Further Information Response

SDCC Reg. Ref. SD22A/0361

**Transitional Care Facility at Unit 21, First Avenue,
Cookstown Industrial Estate, Dublin 24.**

Figure 2: Existing surrounding site conditions

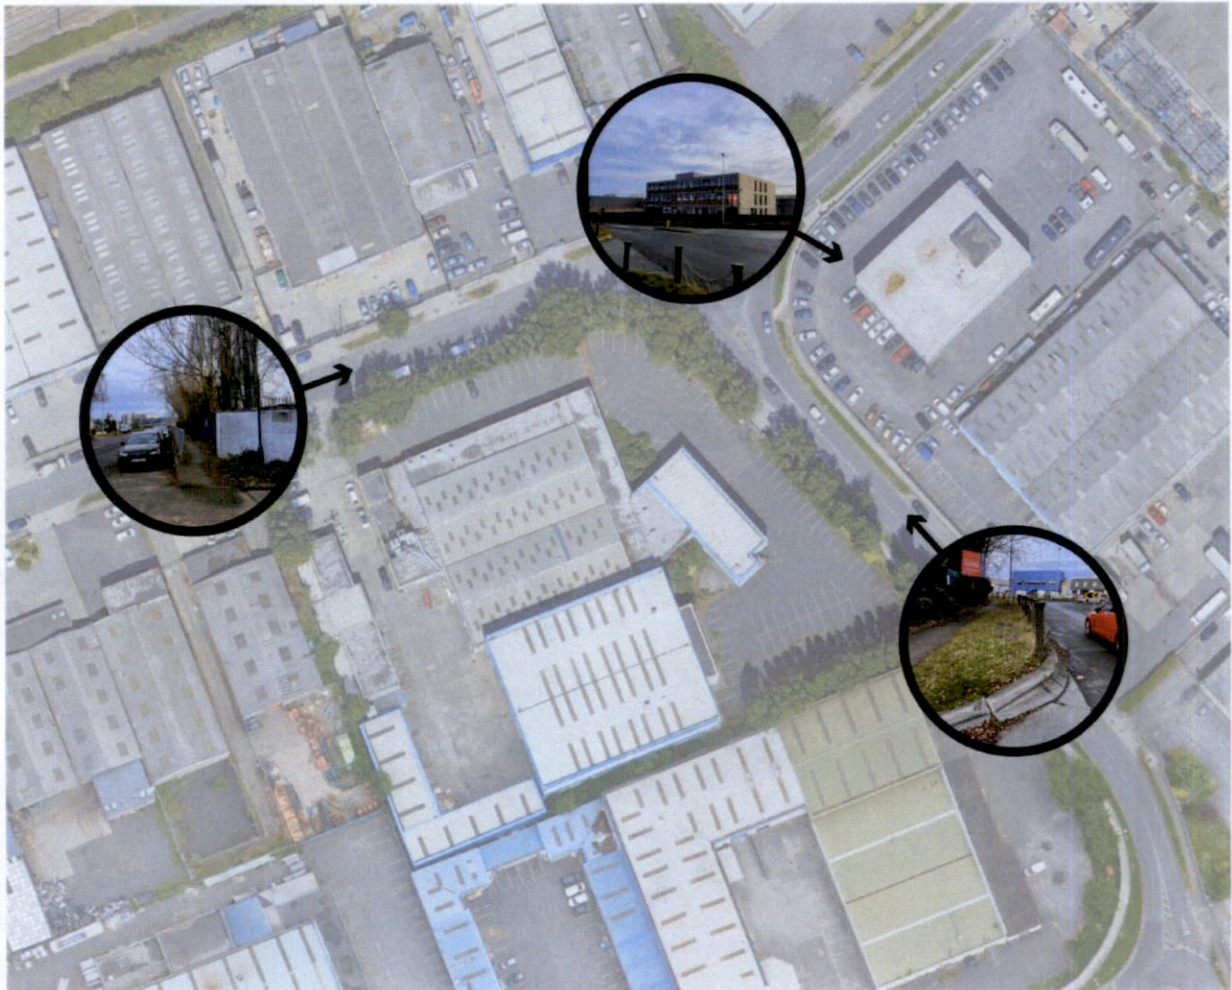
“Notwithstanding the land-use zoning for the site, the Planning Authority has significant concerns in relation to the suitability of the proposed use having regard to the sequencing and phasing provisions set out in the Tallaght LAP. These provisions favour the development of lands closer to Luas Stops and the Town Centre first, unless sites are sufficiently large (over 2ha) to create their own distinct identity/character and amenity. The LAP clearly articulates the need to avoid piecemeal development and isolated sites. In addition, the LAP sets out infrastructure requirements and open space provision that are needed for the development of the CTC sub-neighbourhood within which the subject site is located. These infrastructure requirements have not been fully delivered or designed and as such the Planning Authority is concerned the proposals may be premature. While the provision of temporary pedestrian and cycle linkages as part of these proposals is noted, the Planning Authority requests a more fulsome consideration of the foregoing. Additional information is requested in this regard. In particular, the Applicant may wish to consider additional site assembly to increase the area of land under its control so that it exceeds 2ha. In addition the Applicant is requested to provide details of the specific use of the sites that adjoin the subject site and of lands that lie directly across the public road from the subject site.”

Figure 2 below shows the current condition of the pedestrian areas surrounding the development site and depicts the lack of cycle infrastructure. The subject proposal to provide interim upgrade works to the pedestrian and cycle areas will greatly improve the existing infrastructure in place, which is currently characterised by high curbs, bollards, and undulating pedestrian walkways in poor repair.

Figure 4 – Existing Condition of Public Realm (east of the site on Cookstown Road)

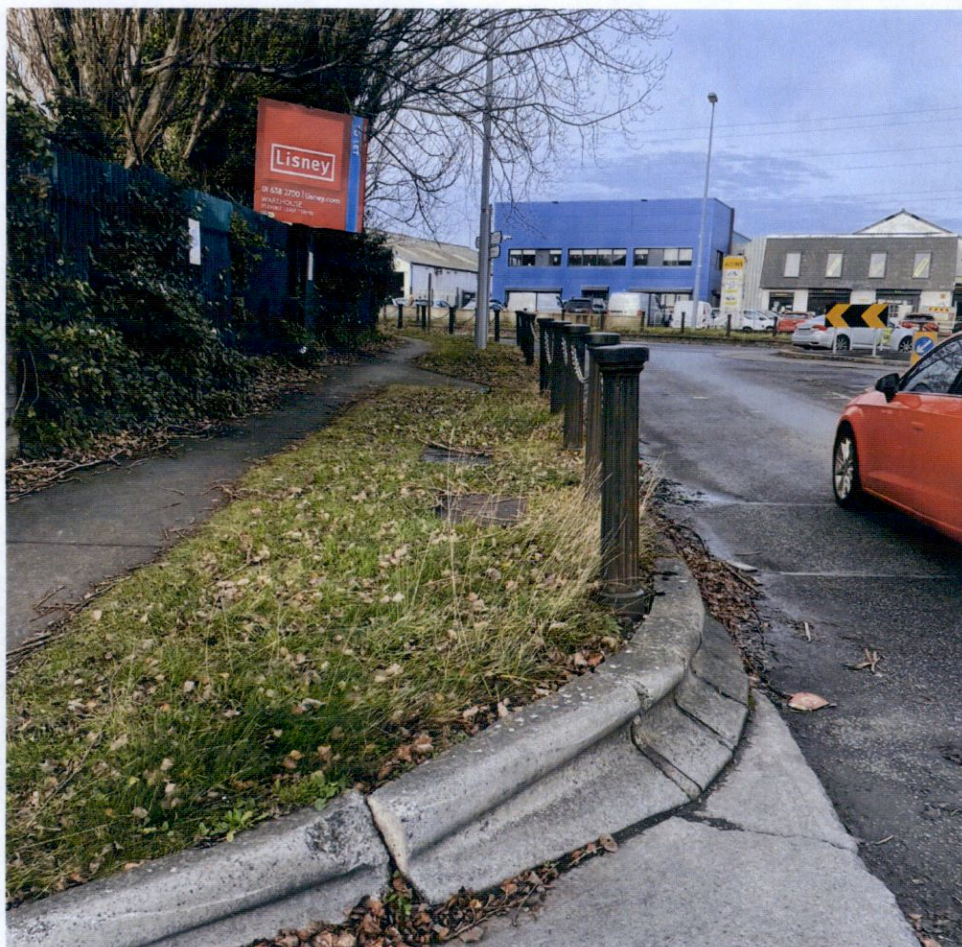
The Applicant is proposing to remove a significant amount of existing green infrastructure around the immediate site boundaries, including trees and grass verges. The Planning Authority does not support the removal of such an excess of green infrastructure, in particular the removal of the grass verge to provide set down and drop off bays serving the development, outside the ownership boundary of the Applicant, and without a suitable replacement/mitigation plan. The use of parts of South Dublin County Council lands on First Avenue and Cookstown Road for set down and drop off bays would undermine the future delivery of a quality public realm in this part of Cookstown, and there would be a concern about how these bays would be used in the interim while Cookstown functions as an industrial estate, with HGV traffic. Any parking and set-down areas connected with the proposals should be provided within the landholding and should not rely on the lands outside the control of the Applicant.”

In response to Item No. 4, we note the existing condition of the public realm consists of grass verges devoid of any mixed species, concrete hard standing pavements and high railings separating the public areas from the existing commercial site, as depicted in Figure 4 below.

The existing grass verge along Cookstown Road is of poor quality and contains a single, small to medium sized birch tree. This verge is sat behind high containment kerbs, the replacement of which will be necessary to achieve an accessible DMURS compliant streetscape. Replacing this verge is therefore a key piece of infrastructural work that must be carried out to realise the objectives of the Tallaght Town Centre Local Area Plan. Concerns regarding the loss of green infrastructure have been noted and the public realm proposals now depict a reduced quantum of set down and parking spaces while delivering a comfortable pedestrian and cycle environment.

Figure 6 – Proposed Taking in Charge (hatched purple)

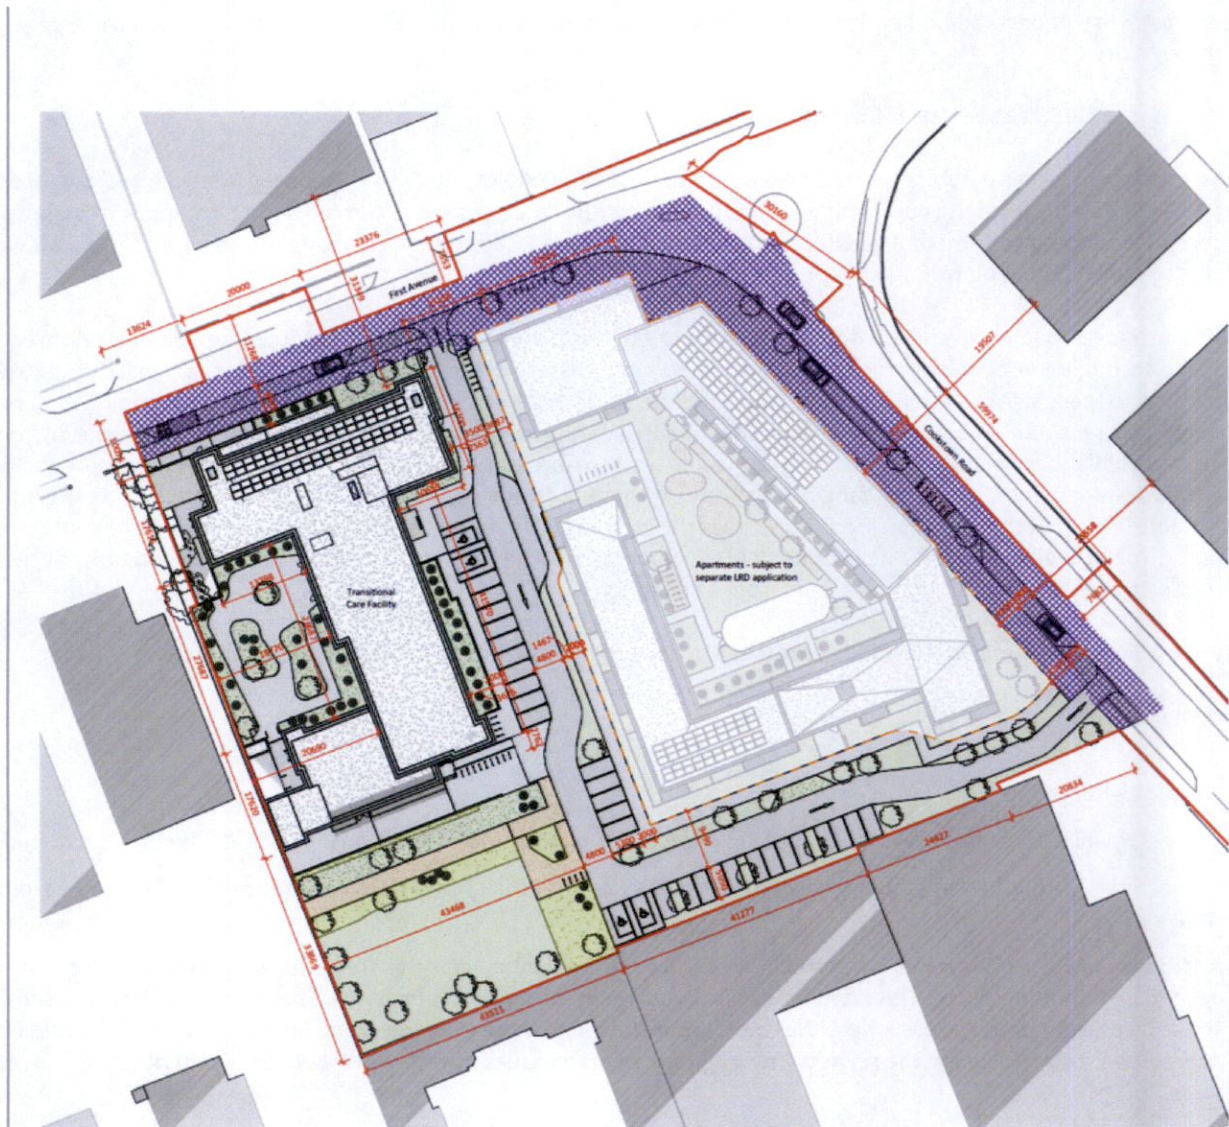
a. The 'Site Lighting Design' drawing layout does not agree with the cycleway layout proposed in the Road Layout Drawings 1-6.

b. If the Road Layout Drawings are correct, the existing street lighting along First Avenue and Cookstown Road will need to be fully re-designed. This has not been included for in the current submission. The Landscape drawings show street trees and parking areas where the road layout drawings show cycleways. The landscape drawing should be revised and should included the revised street lighting plan to ensure co-ordination between lamp posts and street trees.”

In response to Item No. 11, we refer to the Taken in Charge Drawing No. 3514-EML-ZZ-ZZ-DR-A-0009 and Ownership Map Drawing No. 3514-EML-ZZ-08-DR-A-0011 prepared by EML Architects. The drawings indicate that the Applicant owns to the centre point of First Avenue to the north and Cookstown Road to the east. The proposed public realm areas are currently owned by the Applicant.

It is envisaged that the on-street parking and delivery bays to First Avenue and Cookstown Road will be taken in charge by South Dublin County Council, subject to agreement, post-planning.
